**DRAINAGE LETTER FOR ACADEMY GATEWAY SUBDIVISION FILING NO. 1 –
LOT 1 – PROPOSED 7-ELEVEN**

**Re: Lot 1 – Academy Gateway Subdivision Filing No. 1
Drainage Compliance Letter**

ACADEMY GATEWAY SUBDIVISION
 FILING NO. 1
 DRAINAGE MAP
 DEVELOPED CONDITIONS

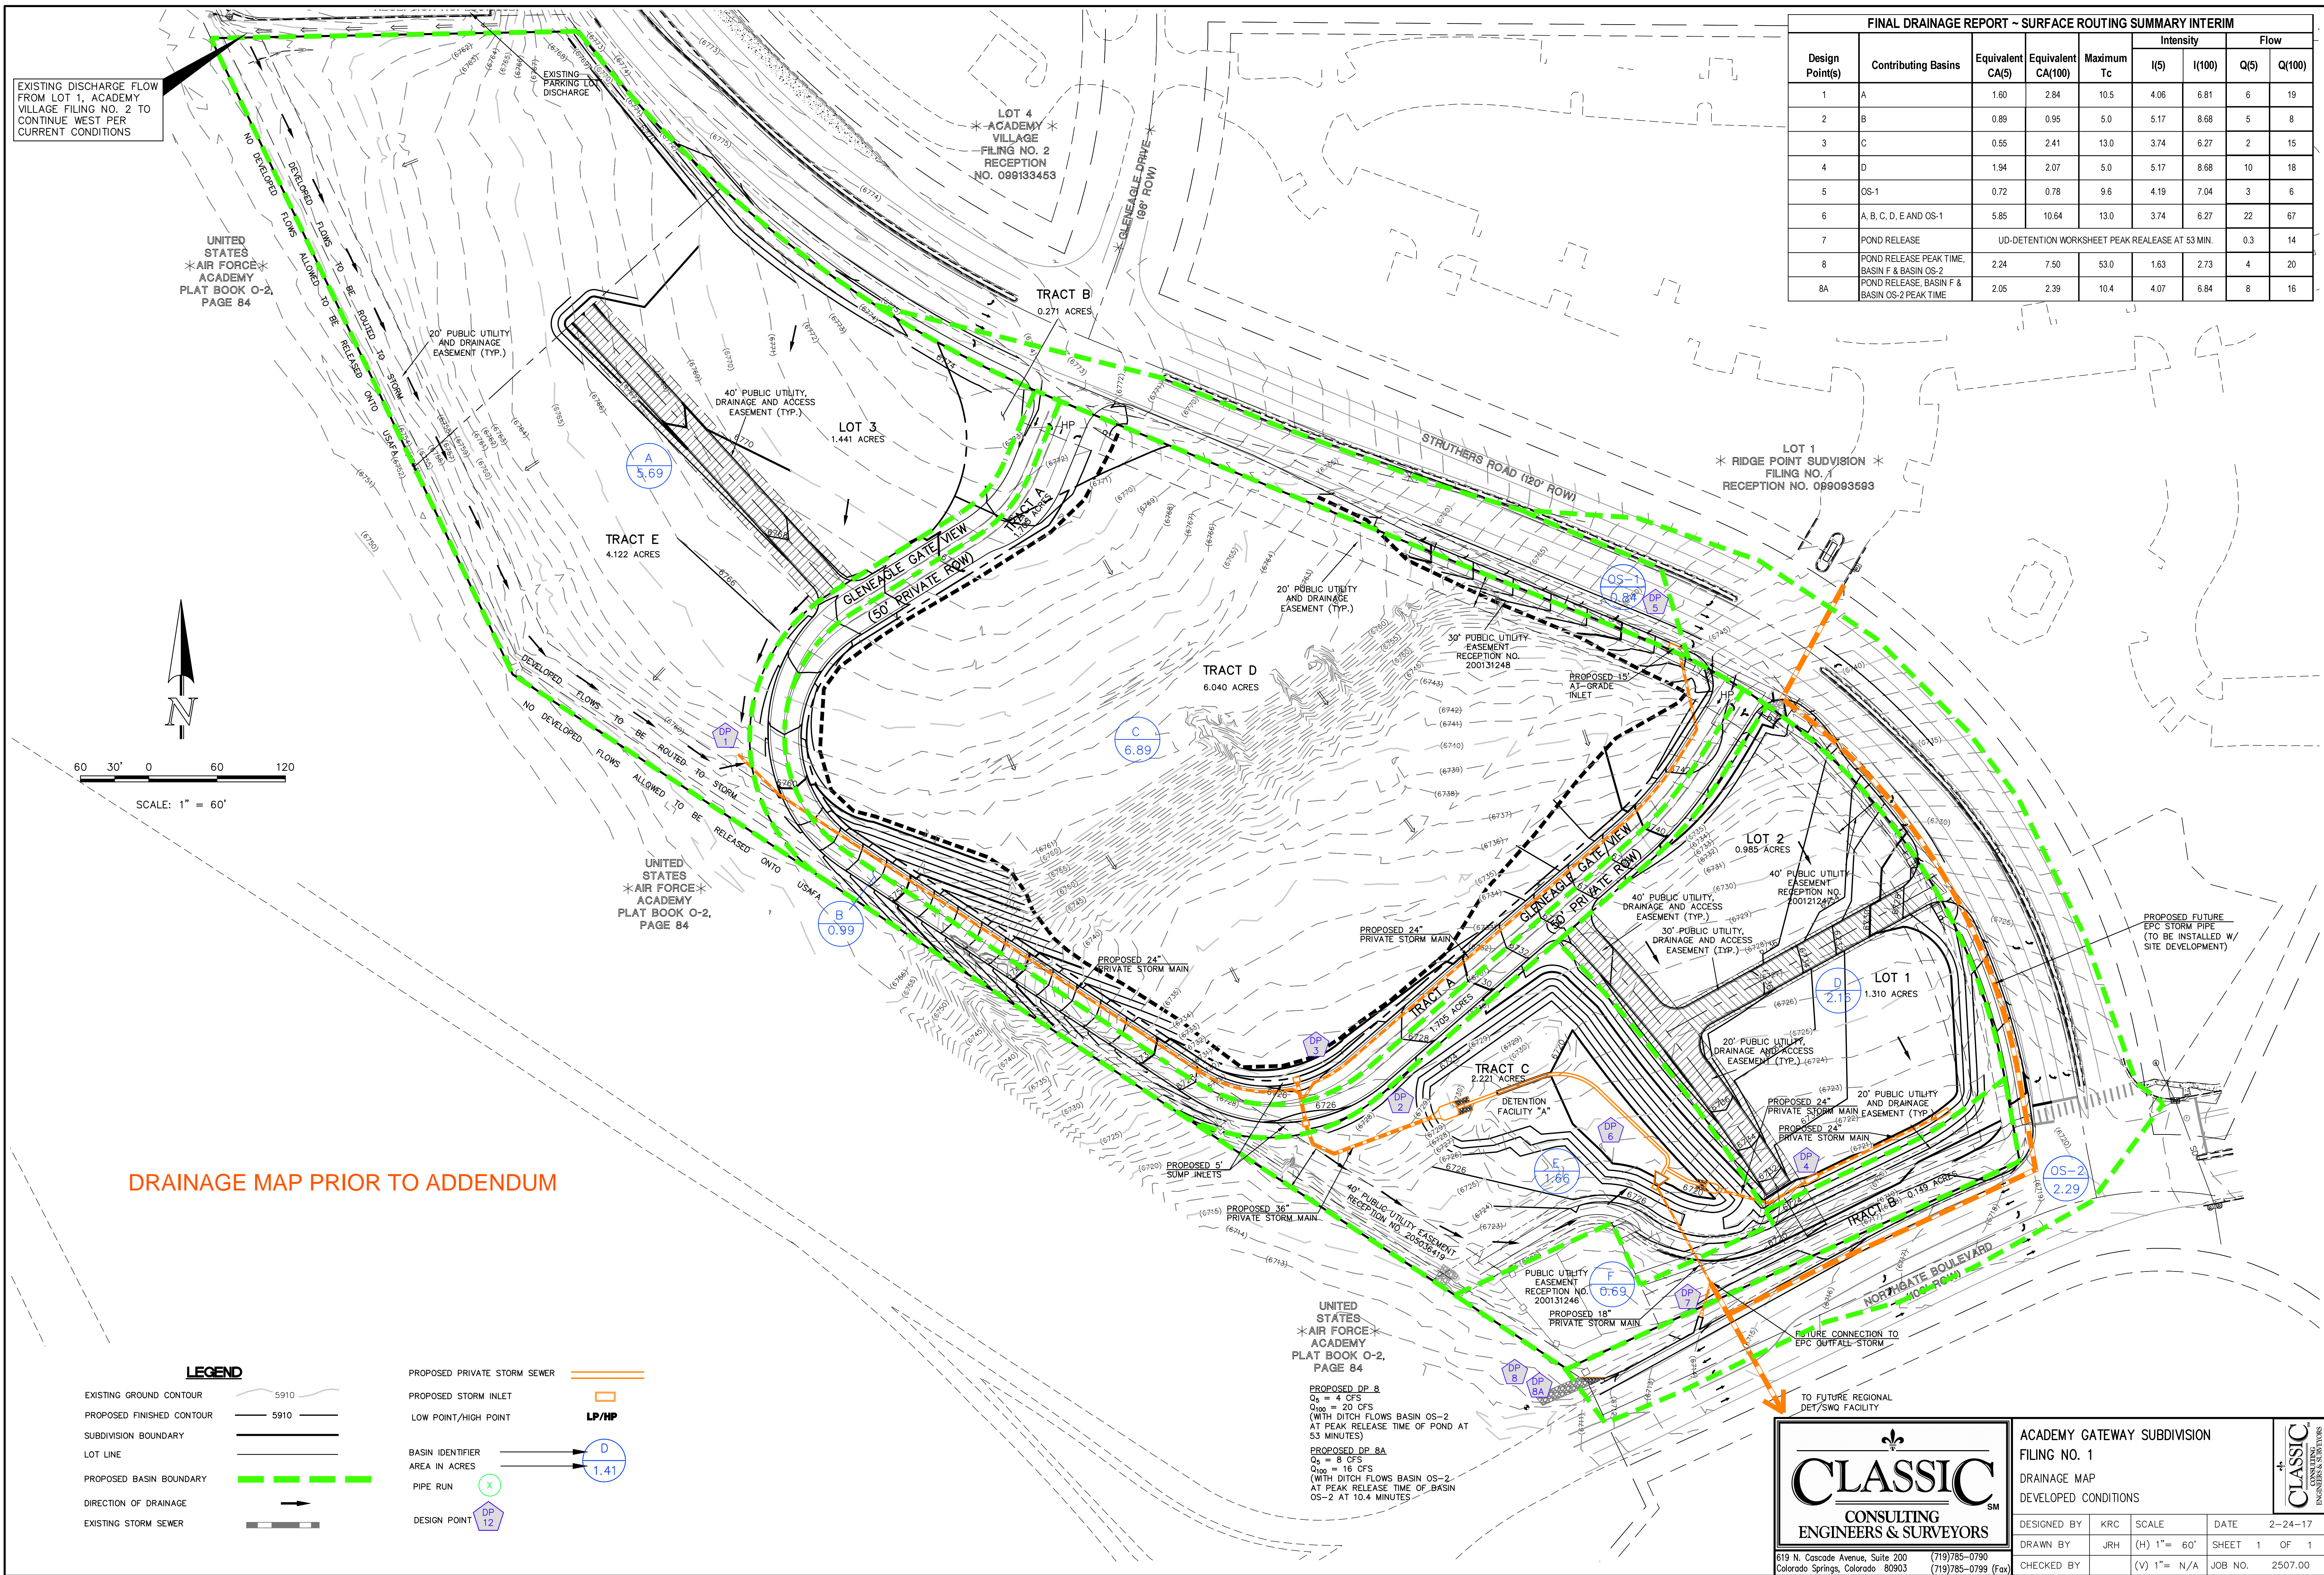
Please move this sheet to be the last page of the document.
